Work Order ID 101996

Item Name: Crosstube, Low Narrow Fwd, 412CF

DRAWING NO. D412-664-145	TITLE CROSSTUBE ASS'Y (412 LOW-N FWD)	REV. D	DART AEROSPACE LTD ENGINEERING ORDER		D.E.O. NO. D412-664-145-D-1	SHEET NO. SHEET 1 OF 2	SCALE NTS
DRAWN <i>q2</i>	CHECKED <i>Sc</i>	MFG. APPR. <i>B</i>	APPROVED <i>MD</i>		DE APPR. <i>TH</i>		
DATE 11.05.25	DATE 11.05.31	DATE 11.05.31	DATE 11/25/31		DATE 11.05.31

PURPOSE:
REPLACE MAGNOBOND WITH PROSEAL.

FIGURE 1: SUPPORT INSTALLATION

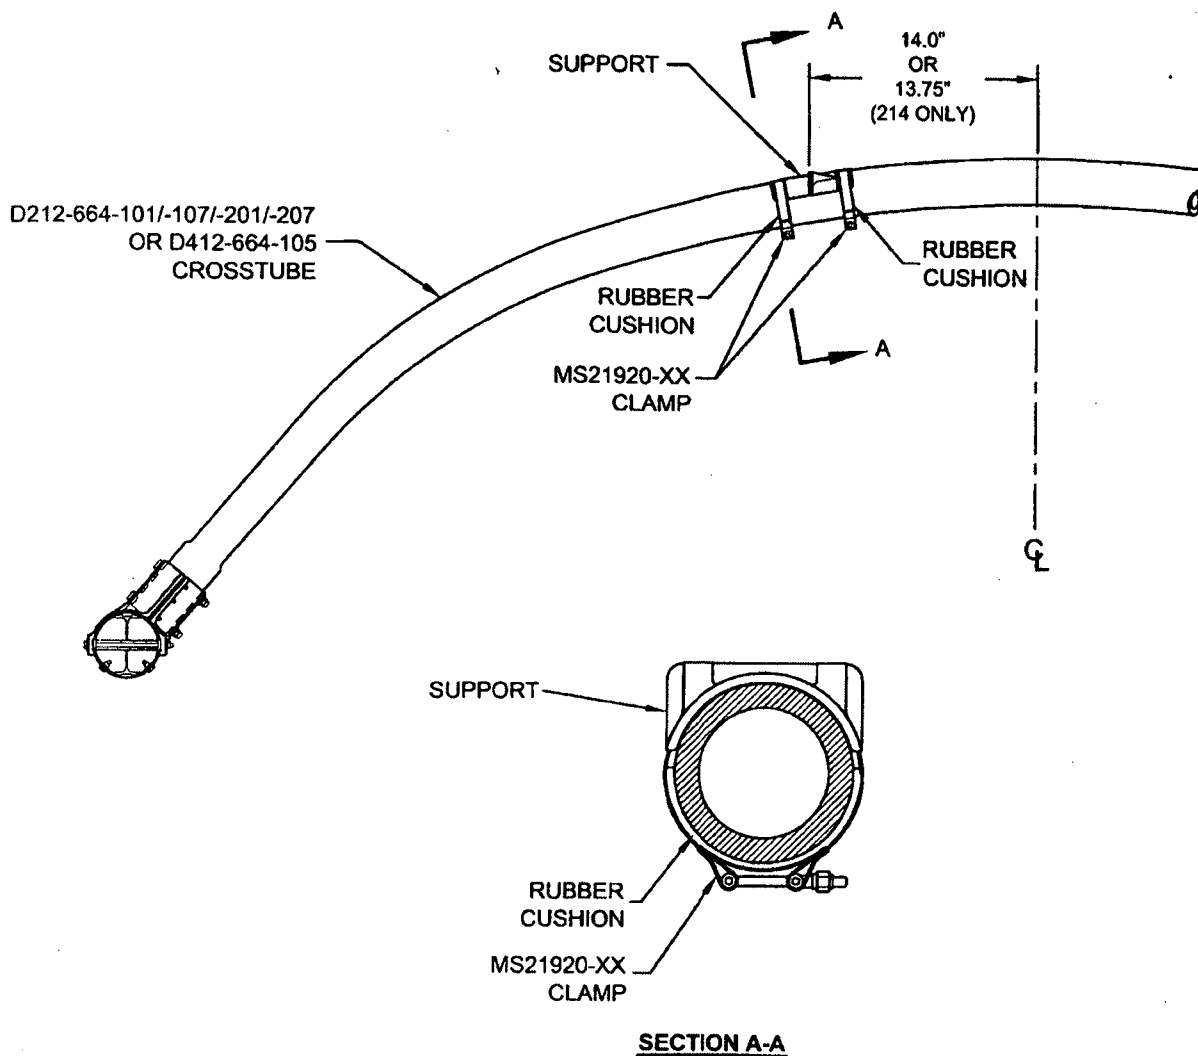
For the crosstubes listed above, section 32.4 of ICA-D212-664 is amended as follows. Use Figure 1 of this service instruction and Figures 32-2 to 32-9 of ICA-D212-664 for further reference. For crosstubes of an earlier change number, it is recommended that if the supports are removed, the supports should be reinstalled using the procedure listed below.

- 32.4.1 Locate the area on the crosstube for installation of support (see Figure 1 of this service instruction). For D212-664-101/-107/-201/-207 and D412-664-105 crosstubes, the outward face of the support tabs should be 14.0" (355mm) from the crosstube center for 204/205/210/412/UH-1 aircraft. For installation on 214B/B-1 aircraft, the outward face of the support tabs should be 13.75" (349mm). Ensure paint finish of crosstube is intact; touch up as required per Chapter 5 (5.3.9) of ICA-D212-664.

- 32.4.5 Apply a 0.04" to 0.07" thick layer of Proseal 890 Class B or AMS-S-8802 Class B sealant underneath applicable support and install support as shown in Figure 1 of this service instruction.

- 32.4.6 Install the clamps opposite to crosstube support as shown in section A-A of Figure 1. Install rubber cushions underneath each clamp around the bottom circumference of the crosstube up to the crosstube centerline. Torque clamps 80-100 in-lb (9.0-11.3 Nm). It is acceptable to use smaller or larger sized MS21920-XX clamps than those listed in ICA-D212-664, ensure that after torquing the clamps per this instruction, the nuts are in safety but not bottomed out

IS:**D412-664-145
ASSEMBLY DETAIL****WAS:****D412-664-145
ASSEMBLY DETAIL****RELEASED**
2011-07-14
MD

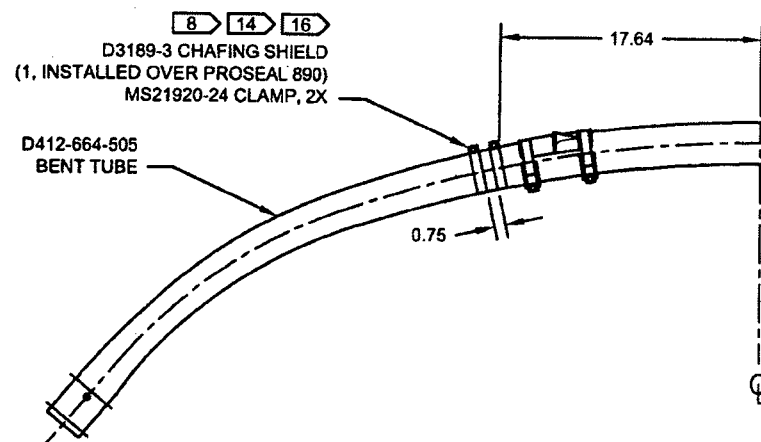
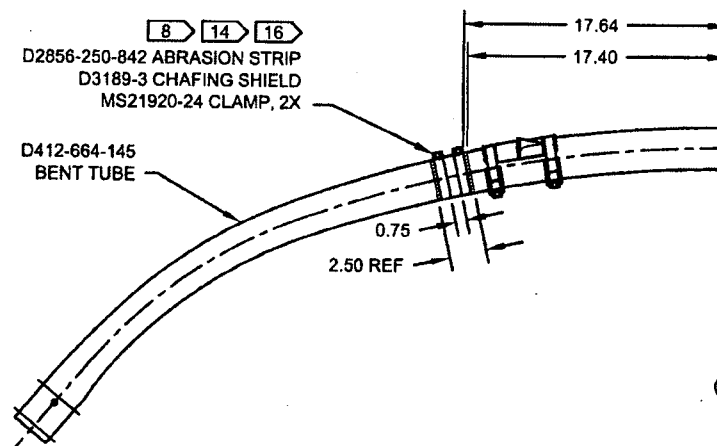
NOTE 14, SHEET 1 IS AMENDED AS FOLLOWS:

**D412-664-145
ASSEMBLY DETAIL**

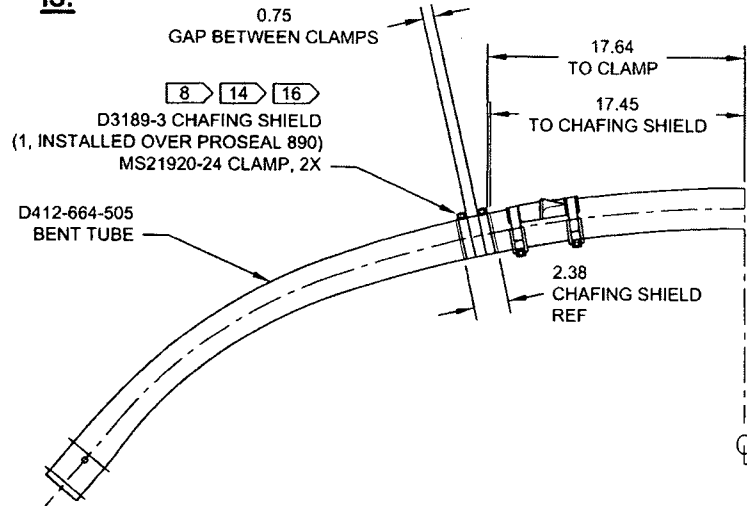
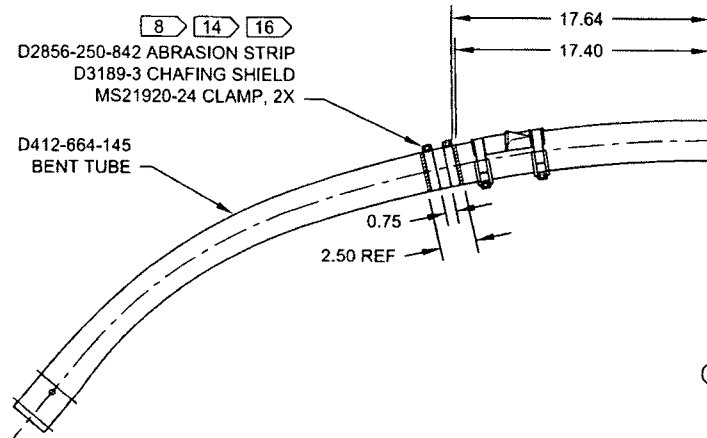
NOTE 14 AND 16 ON SHEET 1 IS AMENDED AS FOLLOWS:
